March 24, 2011
NOC-AE-11002658
File No.: G25
10 CFR 50, Appendix H

South Texas Project
Units 1 & 2
Docket Nos. STN 50-498 & 50-499
Reactor Vessel Material Surveillance Capsule Removal - Revision

**SOUTH TEXAS PROJECT
UNITS 1 AND 2
REVISED REACTOR VESSEL MATERIAL
SURVEILLANCE CAPSULE REMOVAL**

SURVEILLANCE CAPSULE LOCATIONS IN REACTOR PRESSURE VESSEL

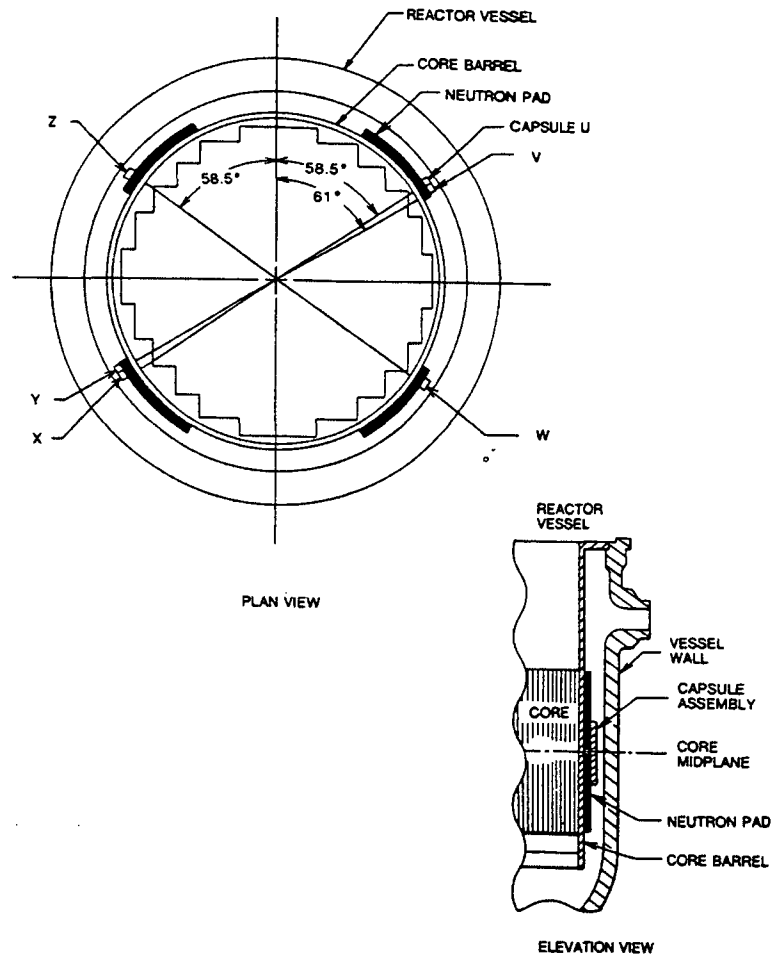
Equipment in place around the reactor pressure vessel needed to conduct a refueling operation block access to the location where capsule X is positioned. Achieving access requires that equipment be repositioned, a process that makes capsule removal a critical path activity and potentially lengthening the duration of the refueling outage. Achieving access to capsule W for removal is not a critical path activity.

There are three surveillance capsules remaining in each reactor pressure vessel (X, W, and Z). See the attached figure. STPNOC has submitted an application to the NRC to extend the licensed operating life of the Unit 1 and 2 (reference 3). Capsule X (both units) was intended to be the source for data to qualify operation for 60 years to support license renewal for the extended plant life. Capsule X was initially chosen because it has the highest lead factor of the three remaining capsules in both units (Table 2). However, the difference between lead factors for X and W is not significant (about 1%).

The previously stated surveillance capsule removal schedule specified capsule X would be removed during refueling outages 1RE16 and 2RE15. Due to limited access to capsule X, capsule W will be pulled instead. NRC approval to utilize an alternate capsule is not considered necessary.

One surveillance capsule per unit will be withdrawn during 1RE16 and 2RE15. Capsule W will be pulled instead of capsule X. The surveillance specimens will have been exposed to neutron fluence for an estimated 18 EFPY by that time. This withdrawal campaign is depicted in the attached STP UFSAR Table 16.1-2, "Reactor Vessel Material Surveillance Program – Withdrawal Schedule." The remaining capsules will be left in place pending further determination.
